UNITED STATES PATENT AND TRADEMARK OFFICE

APPLICATION NO.	FILING DATE	FIRST NAMED INVENTOR	ATTORNEY DOCKET NO.	CONFIRMATION NO.
10/782,385	02/18/2004	Satoshi Mizutani	20050/0200895-US0	3573
7278	7590	11/29/2007		
DARBY & DARBY P.C. P.O. BOX 770 Church Street Station New York, NY 10008-0770			EXAMINER BOGART, MICHAEL G	
			ART UNIT 3761	PAPER NUMBER
			MAIL DATE 11/29/2007	DELIVERY MODE PAPER

Office Action Summary

DETAILED ACTION

FIG. 18

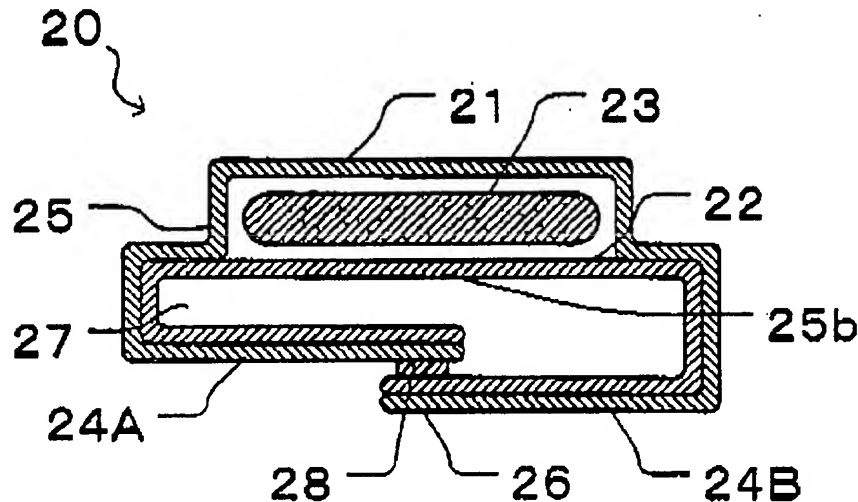
Regarding claim 1, Mizutani teaches an interlabial pad (20) comprising:

a first sheet (21) forming a surface side sheet configured contacting a body, the first sheet (21) having a permeable property for liquid;

a second sheet (22) independent from the first sheet (21) and forming a back face side sheet configured to be positioned away from the body, the second sheet (22) including a plurality of sheet pieces (24A, 24B), each partially overlapping another sheet piece;

an absorbent body (23) for absorbing liquid, the absorbent body (23) being disposed between the surface side sheet (21) and the back face side sheet (22);

a junction joining the surface side sheet (21) and the back face side sheet (22) at a peripheral edge of the absorbent body (23);

at least one seam part (26) of the second sheet (22) formed by overlapping the plurality of sheet pieces (24A, 24B) over one another, the seam part (26) including:

a longitudinal seam part (26) extending in a longitudinal direction of the interlabial pad (20), crossing over the second sheet (22) from an edge to another edge of the second sheet (22)

and an adhesive agent (28) applied between the sheet pieces (24A, 24B) at the longitudinal seam part (26) along a longitudinal central line along the longitudinal direction, wherein the sheet piece (24A), which overlaps the other sheet piece (24B) at the longitudinal seam part (26) and which covers a side closer to the longitudinal central line of the interlabial pad (20), is positioned at the absorbent body (23) side of the second sheet (22) and wherein the sheet pieces (24A, 24B) are each formed of either a water disintegrable material or a biodegradable material to enable separation of the second sheet into the sheet pieces (24A, 24B) when discarded by flushing (§ 0074).

Regarding claims 9 and 20, Mizutani teaches that the back face side sheet (22) is made uneven at least at the surface opposite the absorbent body (23) side (see fig. 18, supra).

FIG. 30

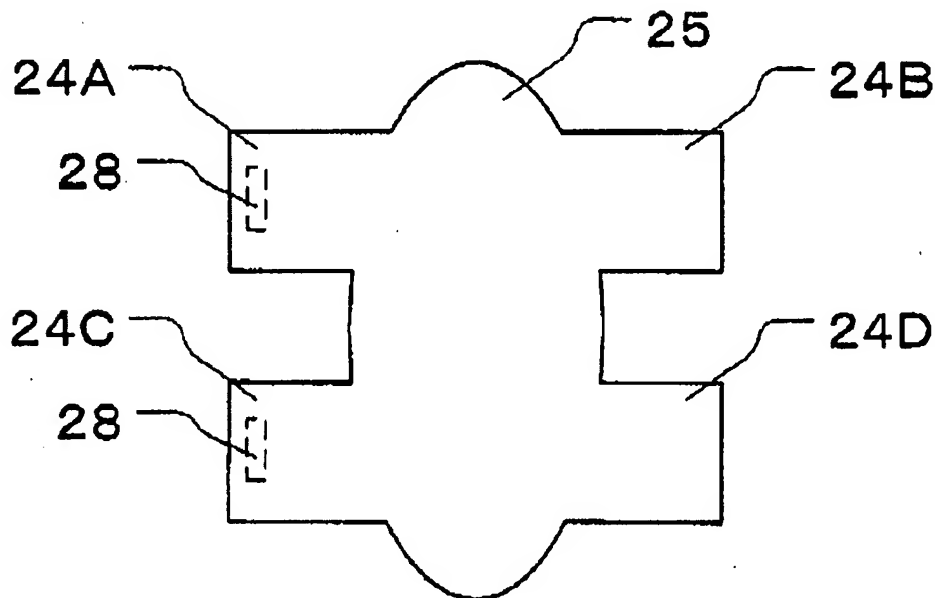
Regarding claims 6, 7 and 23, Mizutani teaches a lateral seam part (25) and a sheet piece (24A) overlapping a sheet piece (24B) at the seam part (see fig. 30, infra). Regarding the functional limitations of the claim, apparatus claims must be structurally distinguishable over the prior art. MPEP § 2114. The device of Mizutani can be folded in the claimed manner.

FIG. 1

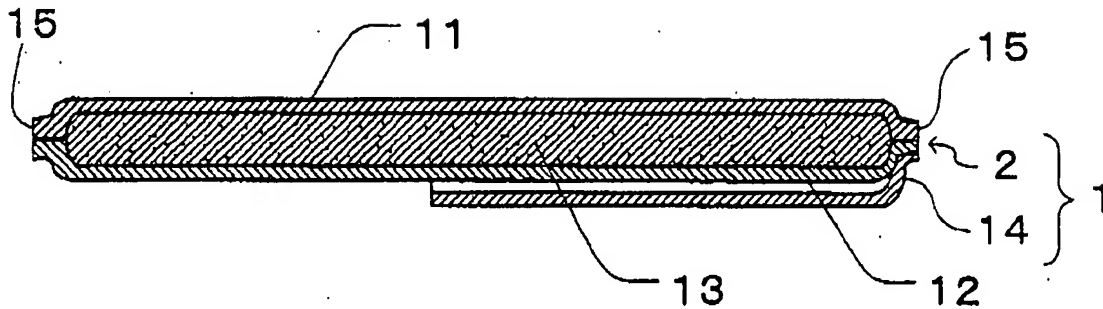
Regarding claim 27, Mizutani teaches a mini sheet piece (14) attached at the junction (2) of sheets (11) and (12)(see fig. 1, *infra*).
